UNITED STATES PATENT AND TRADEMARK OFFICE

Office Action Summary	Application No. 10/561,331	Applicant(s) BAILEY, MARSHALL GRAHAM	
	Examiner BENJAMIN KURTZ	Art Unit 1797

DETAILED ACTION

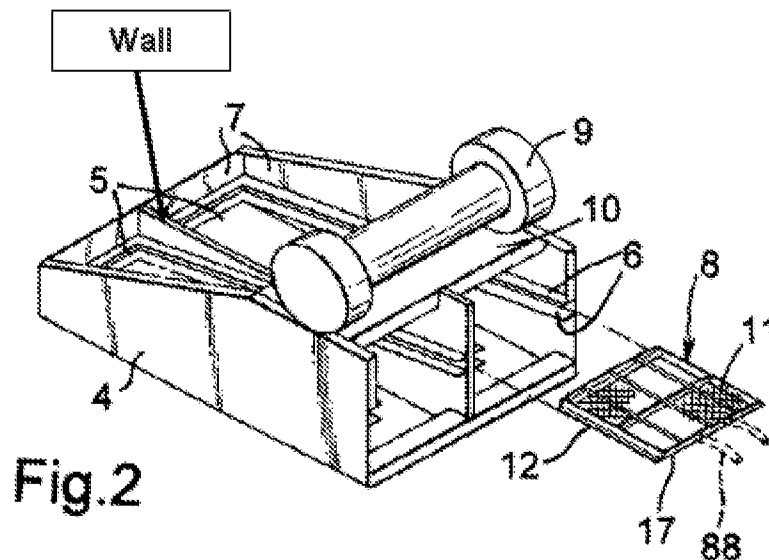
Claims 13, 16 and 17, Wiseman teaches the basket of claim 9 but does not teach the flow distributor including a wall. WO teaches a basket comprising a flow distributor comprising a wall/lateral divider (see below) formed and arranged to define a plurality of laterally adjacent flow pathways (fig. 2, below). The claim would have been obvious because all the claimed elements were known in the prior art and one skilled in the art could have combined the elements by known methods with no change in their respective functions and the combination would have yielded predictable results to one of ordinary skill in the art at the time of the invention, *KSR International Co. v. Teleflex Inc.*, 82 USPQ2d 1385 (2007).

Providing a lateral divider (wall, above) is known in the art as shown by WO. The claim would have been obvious because all the claimed elements were known in the prior art and one skilled in the art could have combined the elements by known methods with no change in their respective functions and the combination would have yielded predictable results to one of ordinary skill in the art at the time of the invention, *KSR International Co. v. Teleflex Inc.*, 82 USPQ2d 1385 (2007).
